## Product Change Notice (PCN)

PCN Number: **PCN-0451149R-01**

Product(s) Affected: PJ-037B

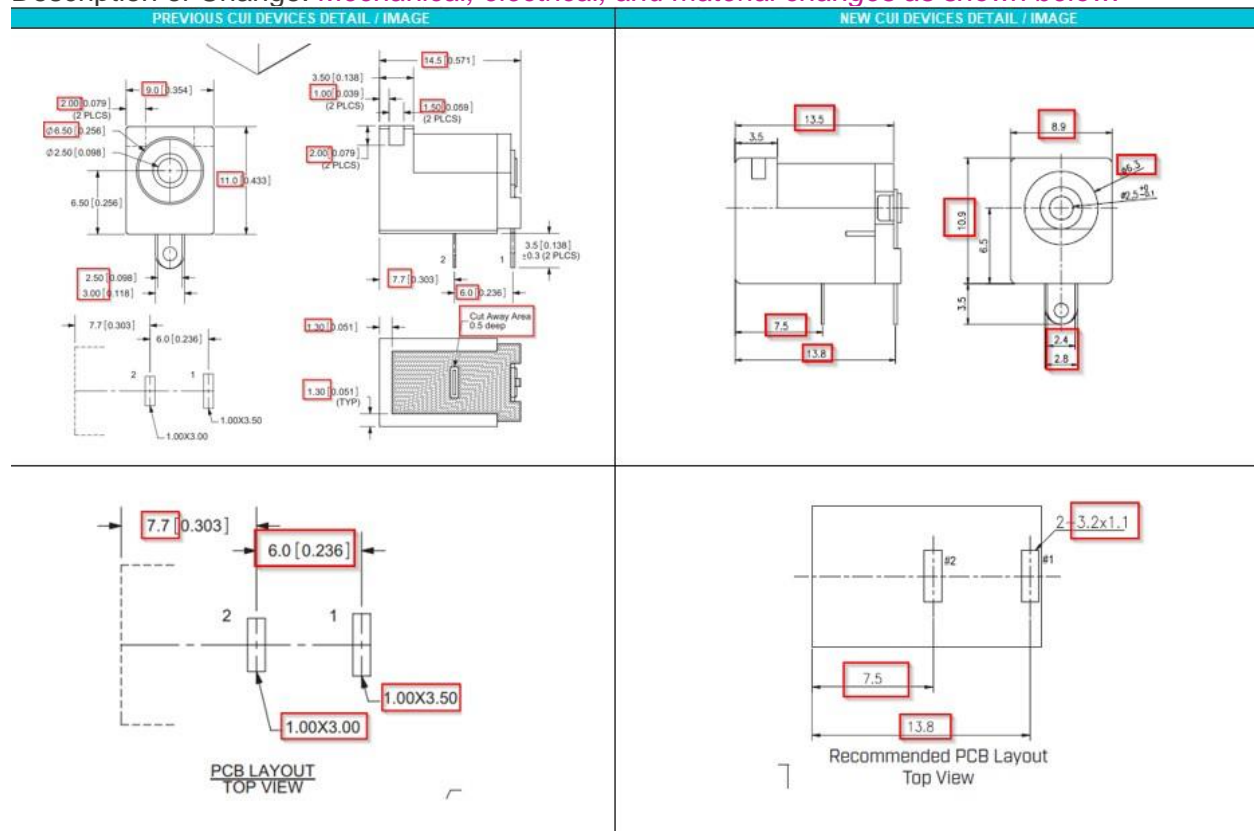
Description of Change: *Mechanical, electrical, and material changes as shown below:*

MATING PLUG  
Jack Insertion Depth: **9.0 mm**

MATING PLUG  
Jack Insertion Depth: **9.8 mm**

MATERIAL	PLATING
center pin	<b>copper</b>	nickel
terminal 1	brass	<b>tin</b>
terminal 2	<b>copper alloy</b>	<b>tin</b>
plastic	PBT

DESCRIPTION	MATERIAL	PLATING/COLOR
center pin	<b>copper alloy</b>	nickel
terminal 1	brass t=0.3 mm	<b>nickel-silver</b>
terminal 2	<b>phosphor bronze t=0.3 mm</b>	<b>nickel-silver</b>
housing	PBT (UL94V-0)	black
cover	PBT (UL94V-0)	black

Insertion/Extraction force adjusted to 0.3 ~ 2.0Kg
